Access Compliance Report

Public Rights-of-Way

| Intersection ID: 14278 | Main Street: ROMARE_BEARDEN_DR | Cross Street: FARMER_ST | Location: SE |
| ADA ID: AD12077A3A33 | Ramp Type: Perp | Initial Pass/Fail: Fail | Overall Compliance: No |

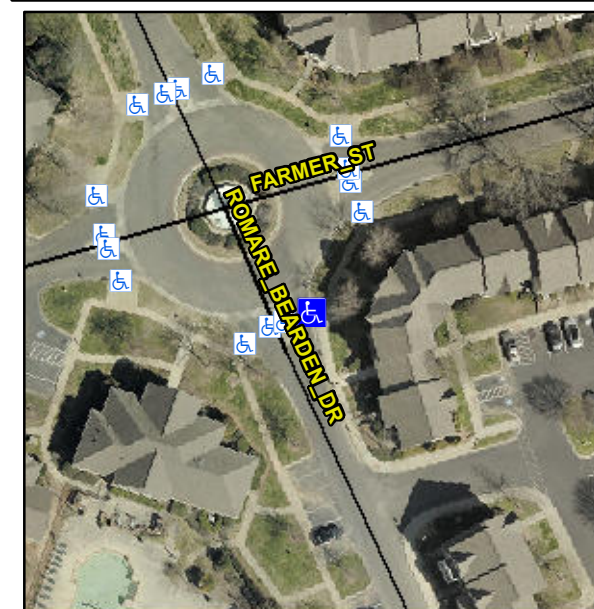
R304.5.3

| Compliance | Description | Data | Compliance | Description | Data |
|------------|-----------------------|------|------------|-----------------------------|------|
| Yes | Ramp Width (in) | 53.0 | No | Ramp XSlope (%) | 3.0 |

Remove & Replace Entire Ramp.
